SITE MANAGEMENT TEAM MONTHLY CALL SUMMARY
FORMER DEFENSE DEPOT MEMPHIS, TENNESSEE
14 JUNE 2022
11:00 EDT

Offsite Groundwater Investigation

Figure 27
Dunn Field Fluvial Aquifer
TCE Concentrations,
April 2019

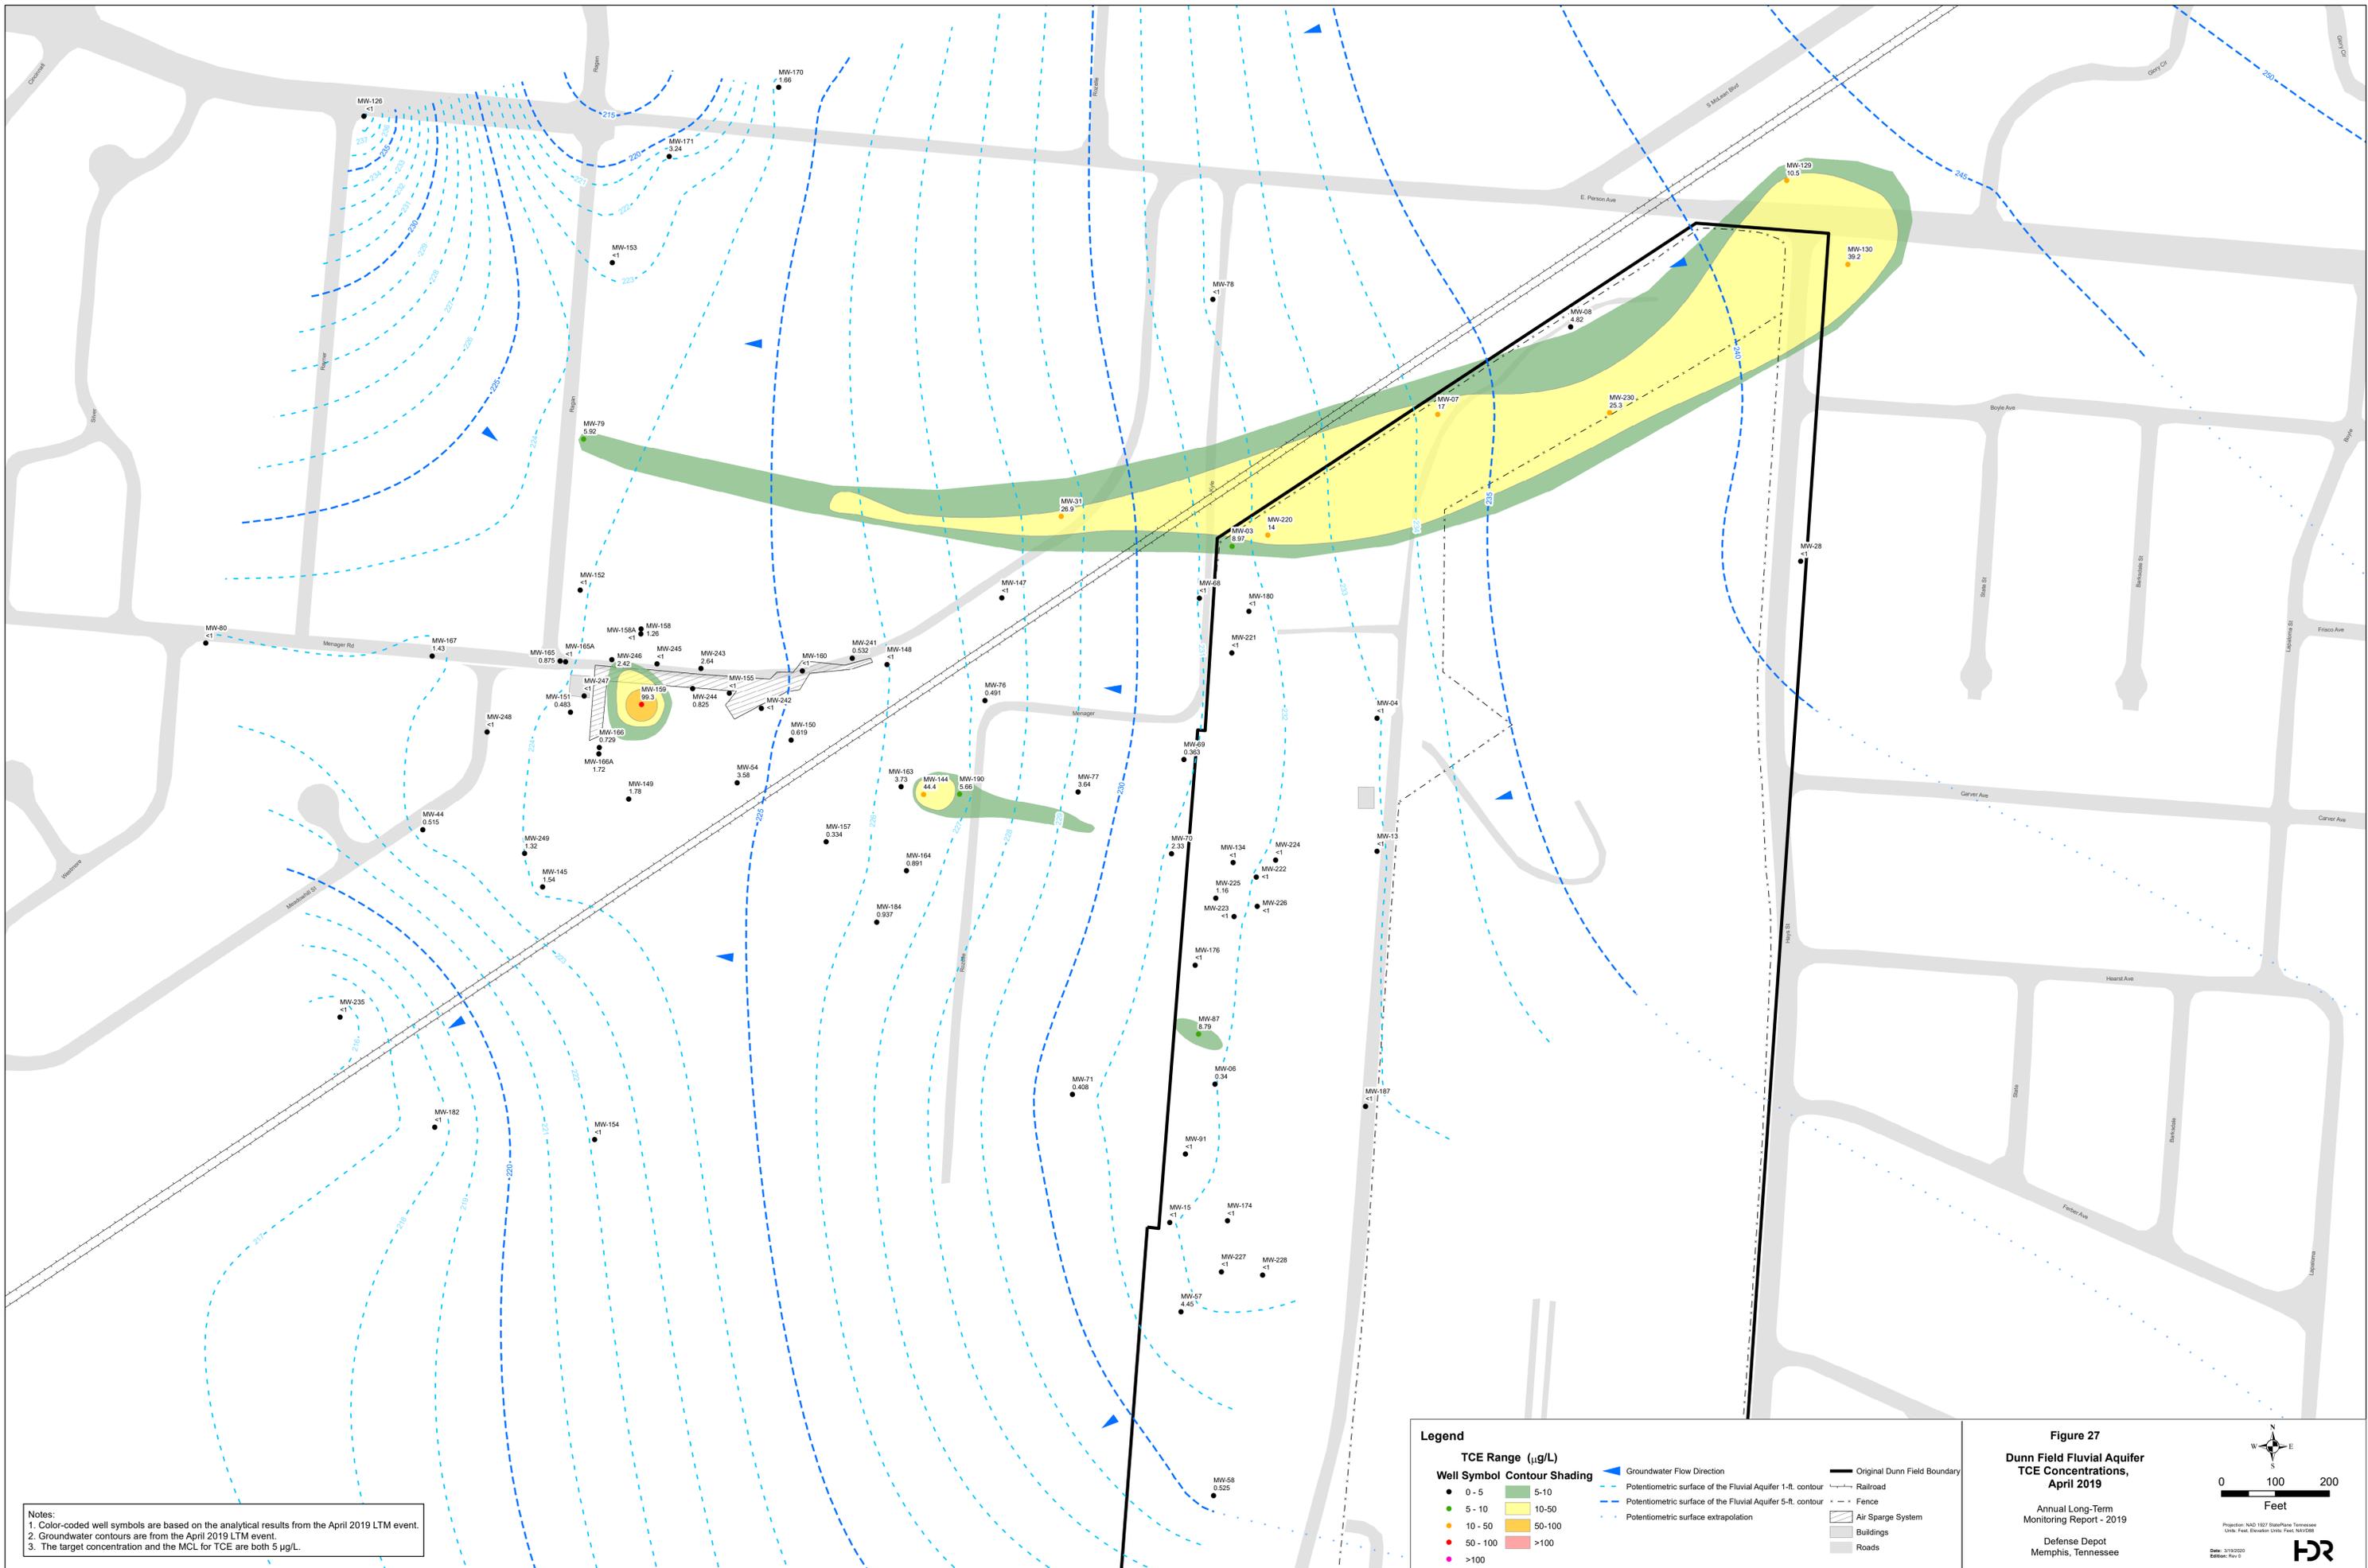
Mr. Holmes said he would like to discuss the comment about OSI plume extent. The OSI report asserts that the plume does not extend past MW-79. Figures from the 2013 and 2019 LTM reports show the plume terminating near MW-79 were shared. PCE and TCE concentrations were slightly above the MCL at MW-79 with non-detect results downgradient (south). The plume does not extend into an area of vertical leakage window where it could reach the Memphis Aquifer. The plume is mainly impacting commercial property, except for the residential area in the upgradient portion of the plume.
